# **ADDENDUM**

**RFB NO. 318029 - ADDENDUM NO. 2**

**FISH HATCHERY HIGHWAY GARAGE – CNG RETROFIT**

**ELECTRICAL ROOM, ELEVATIONS, & RISER PLAN**

**4 ELECTRICAL ROOM FLOOR PLAN**  
E501 SCALE: 1/2" = 1'-0"

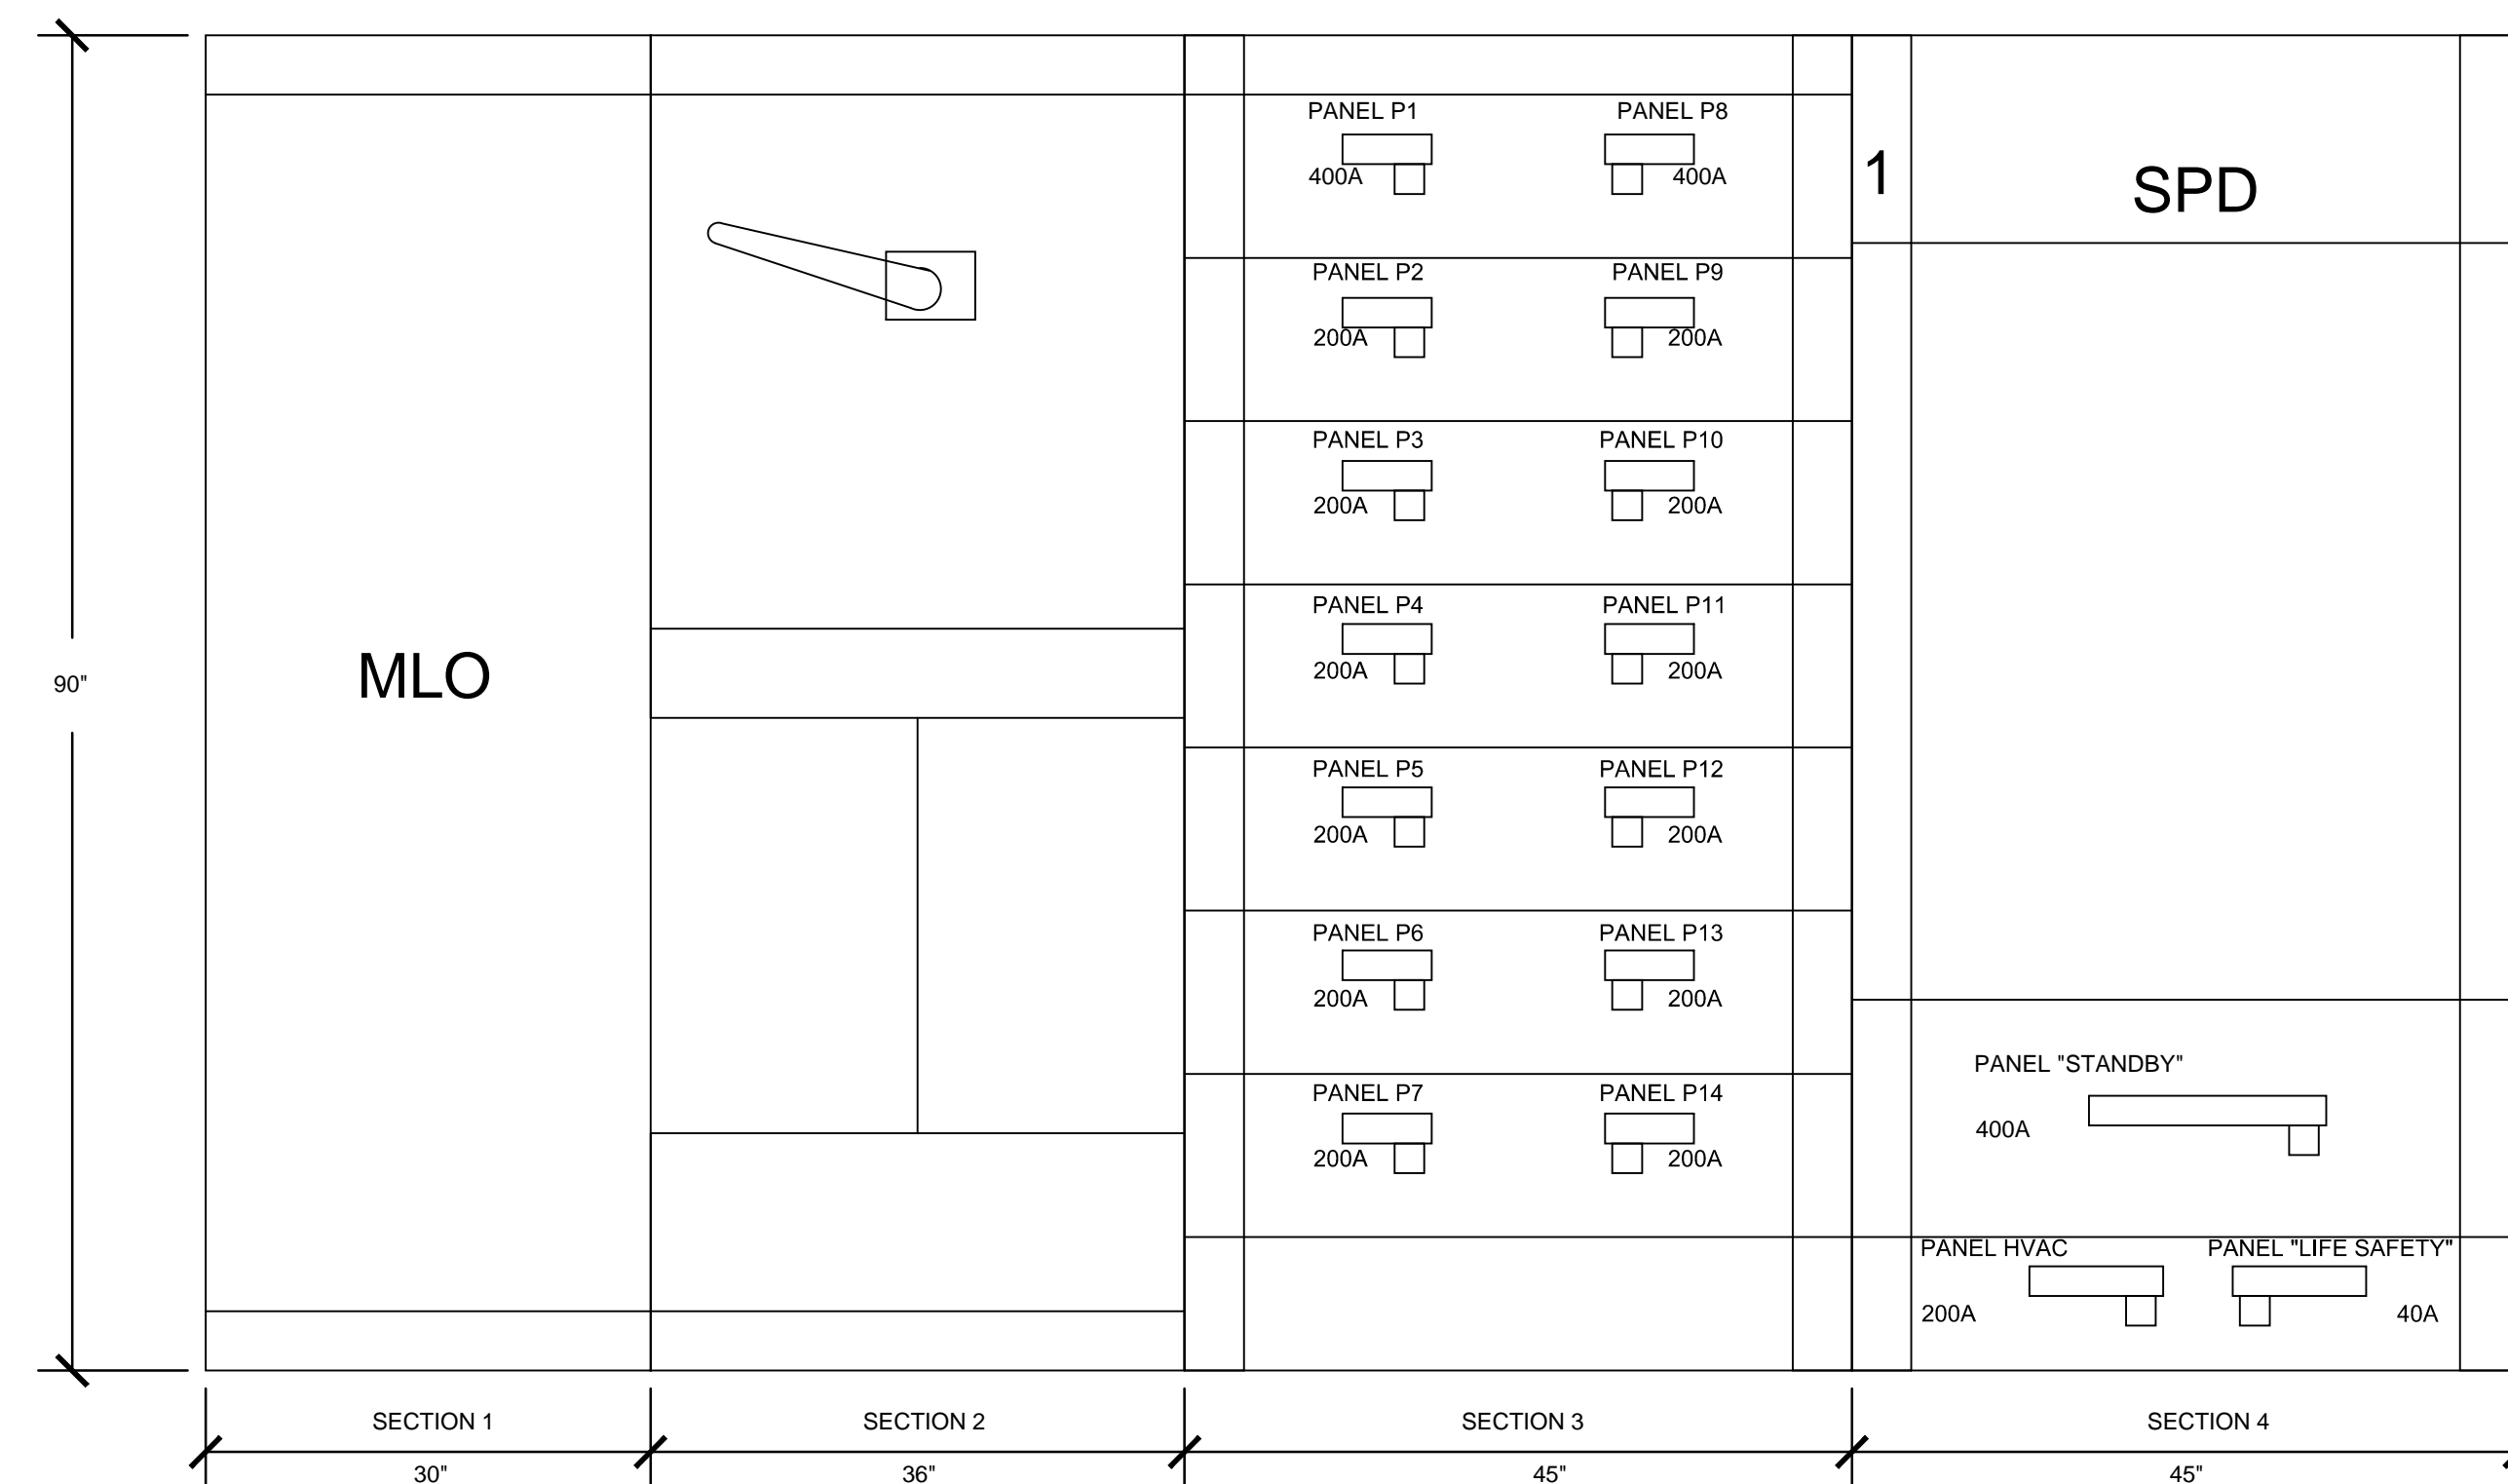
#### **5. Drawing E501 – Electrical Room, Elevations, and Riser Plan**

Revise Electrical Room size, Layout and Service Entrance as indicated.
